Remarks

The following numbered paragraphs are provided to respond to the similarly numbered paragraphs in the Office Action (e.g., paragraph "1" below corresponds to paragraph 1 in the Office Action).

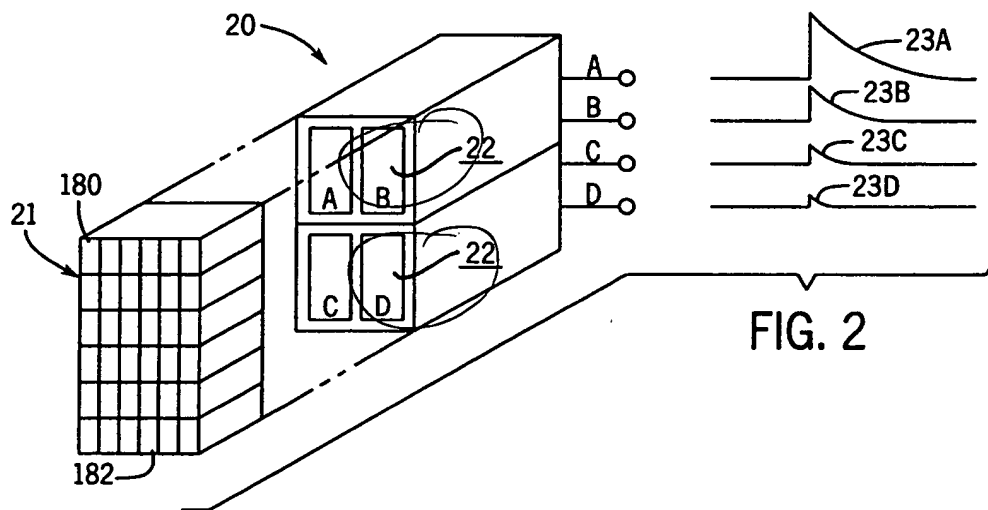
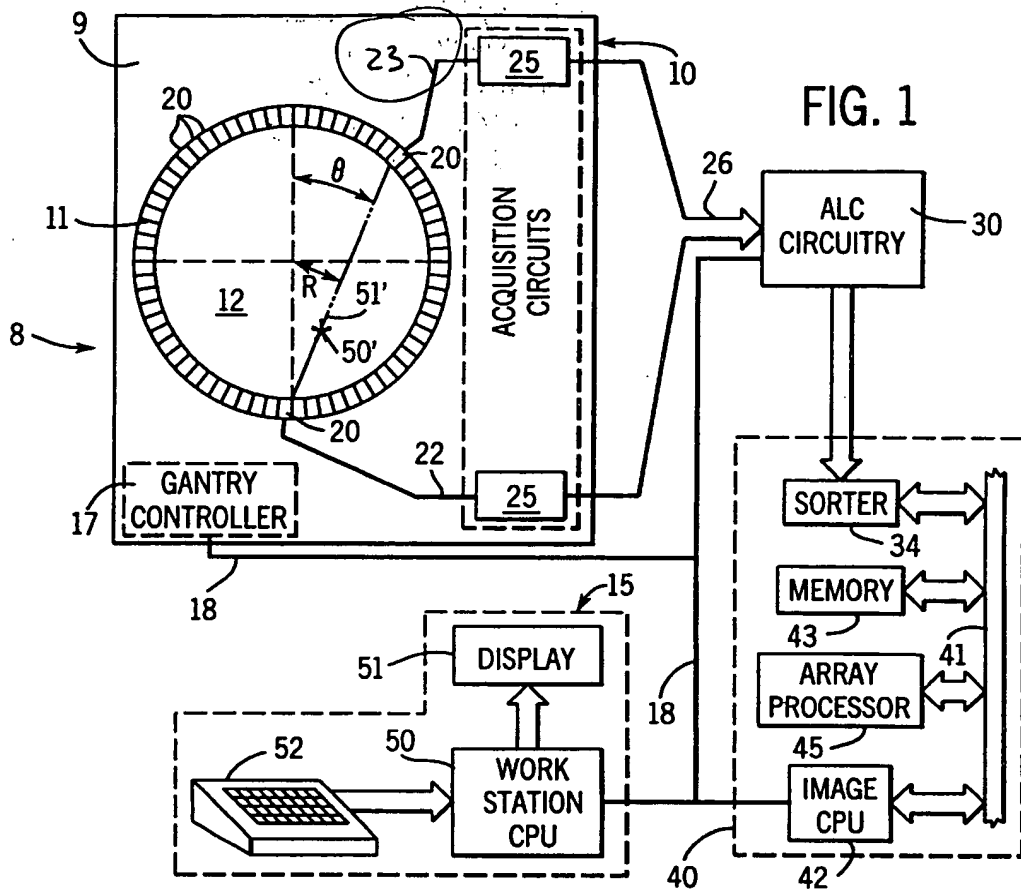
5. Applicant has amended the specification so that the identified reference numbers are referred to therein. The reference numeral 23 has been removed from Fig. 1.

Fig. 3

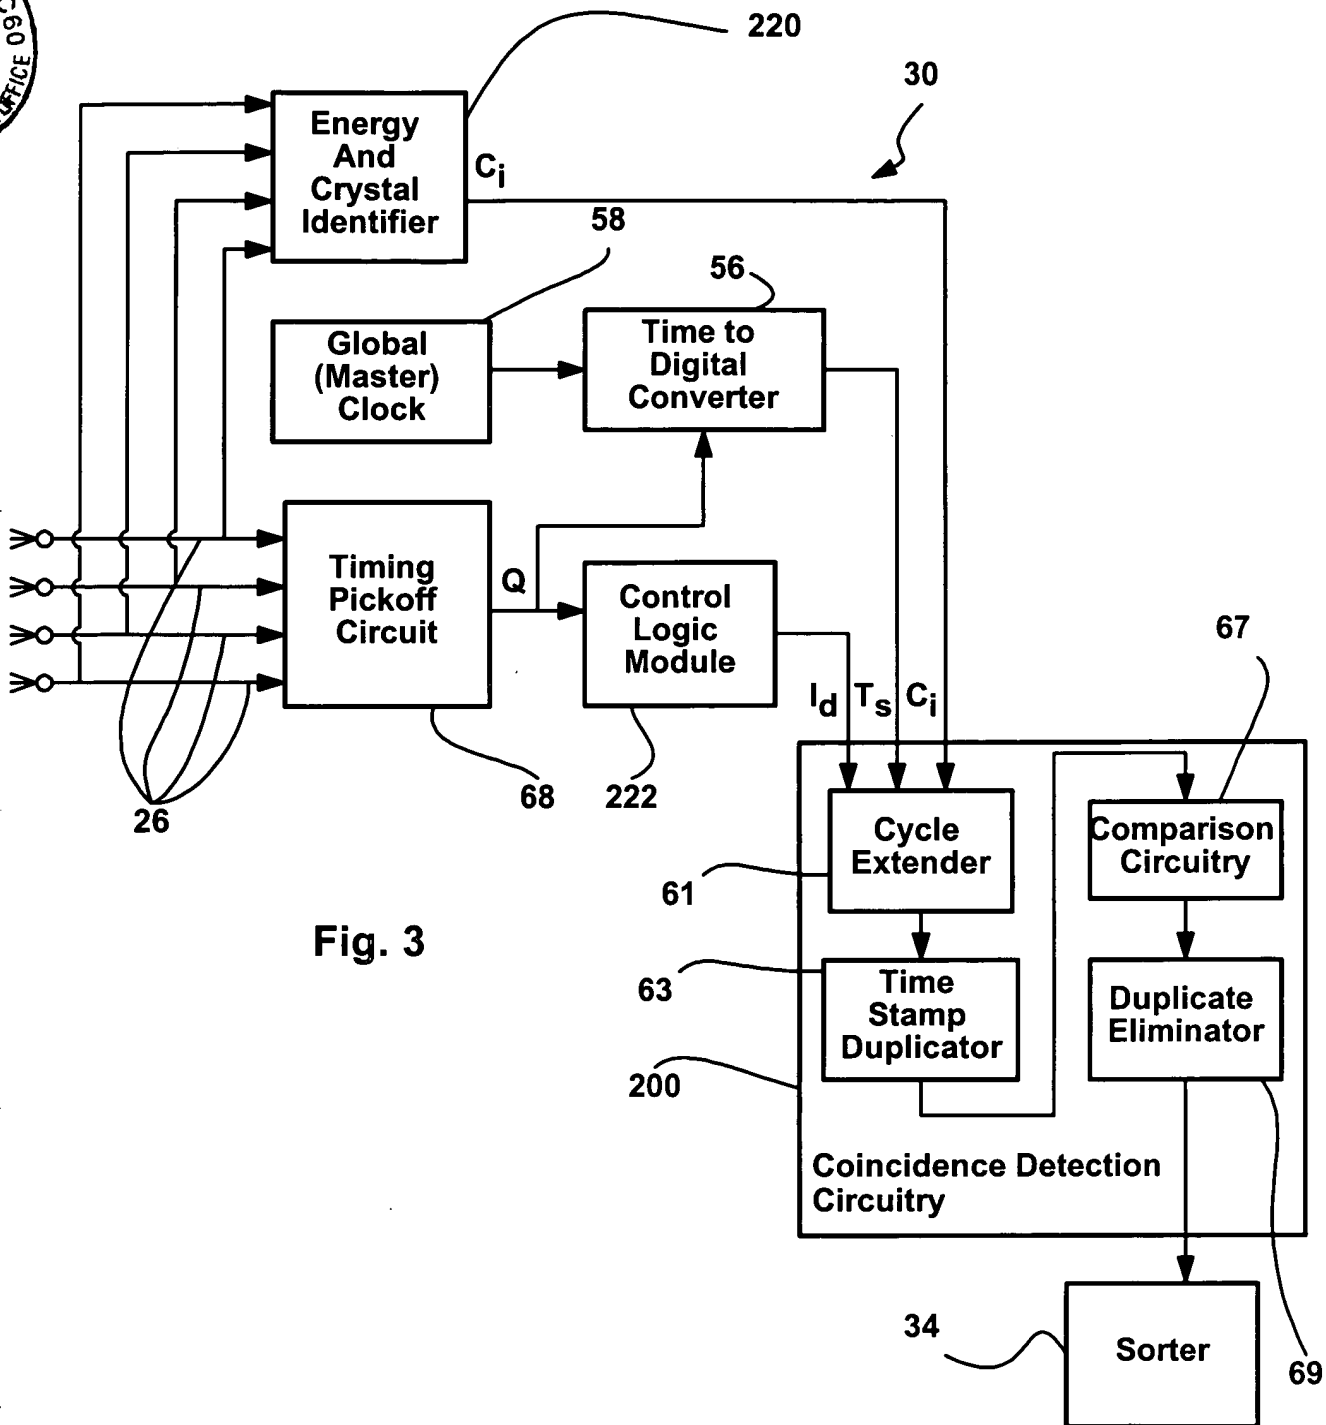
For a better understanding of why Q signals have been shifted in the past refer to Fig. 3 of the present specification and associated text at the end of paragraph 43. In Fig. 3, signals on lines 26 propagate through the illustrated circuitry along two general paths, a first through identifier 220 and a second through TPC 68 and converter 56/module 222. In many cases the propagation times through the first and second paths are different. For instance, in the exemplary case described in paragraph 43 it is assumed that the propagation time difference is 64 nanoseconds (i.e., the processing time along the path through identifier 220 is 64 nsec. greater than the processing time along the other path through converter 56/module 222).

Despite the propagation time difference, the signals provided to circuitry 200 have to be re-sinced prior to processing by circuitry 200. Where the propagation delay is 64 nsec. the signals can be re-sinced by delaying the path through converter 56/module 222 by 64 nsec. (see, in this regard, paragraph 43, lines 7-9 that states "Thus, for instance, in some cases each EDP Q will be delayed for tens of
